MEYLE[®]
Products

MEYLE No.
100 610 0024/HD

Control arm bushing to fit Audi Q7, VW Toureg

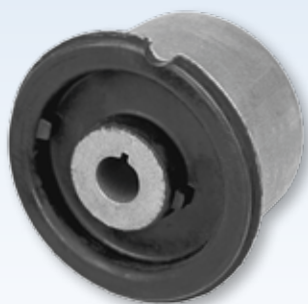
Leakage of hydro fluid due to high dynamic loads and only partial rubber-metal bond

Noise and reduced driving and braking safety

Replacement of the hydromount with an optimized all-rubber mount with a generously-dimensioned rubber-metal bond

No leakage possible and significant longer lifetime without restriction of driving comfort
